TVA-BFN-TS-401

BROWNS FERRY NUCLEAR PLANT (BFN) - UNITS 2 AND 3 - TECHNICAL SPECIFICATIONS (TS) CHANGE 401 - CHANGES TO LIMITING CONDITION FOR OPERATION (LCO) TIME FOR CONTAINMENT ATMOSPHERE DILUTION (CAD) SUBSYSTEM INOPERABILITY

PROPOSED TECHNICAL SPECIFICATIONS (TS) CHANGE TS-401
CHANGES TO LIMITING CONDITION FOR OPERATION (LCO) TIME FOR
CONTAINMENT ATMOSPHERE DILUTION (CAD) SUBSYSTEM INOPERABILITY
INDEX OF ENCLOSURES

PROPOSED TECHNICAL SPECIFICATIONS (TS) CHANGE TS-401
CHANGES TO LIMITING CONDITION FOR OPERATION (LCO) TIME FOR
CONTAINMENT ATMOSPHERE DILUTION (CAD) SUBSYSTEM INOPERABILITY

3.6.3.1 Containment Atmosphere Dilution (CAD) System

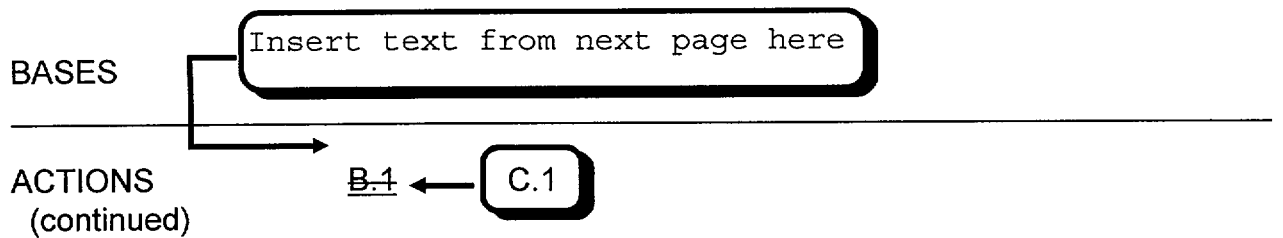
[note: new text below is shown in **bold** type in the shaded areas]

CONDITION	REQUIRED ACTION	COMPLETION TIME
A. One CAD subsystem inoperable.	<p>-----NOTE----- LCO 3.0.4 is not applicable -----</p> <p>A.1 Restore CAD subsystem to OPERABLE status.</p>	30 days
B. Two CAD subsystems inoperable	<p>B.1 Verify by administrative means that the hydrogen control function is maintained.</p> <p>AND</p> <p>B.2 Restore CAD subsystem nitrogen admission flowpath to OPERABLE status</p>	<p>1 hour</p> <p>AND</p> <p>once per 12 hours thereafter</p> <p>7 days</p>
<p>B- Required Action and associated Completion Time not met.</p>	<p>B.4 Be in MODE 3.</p>	12 hours
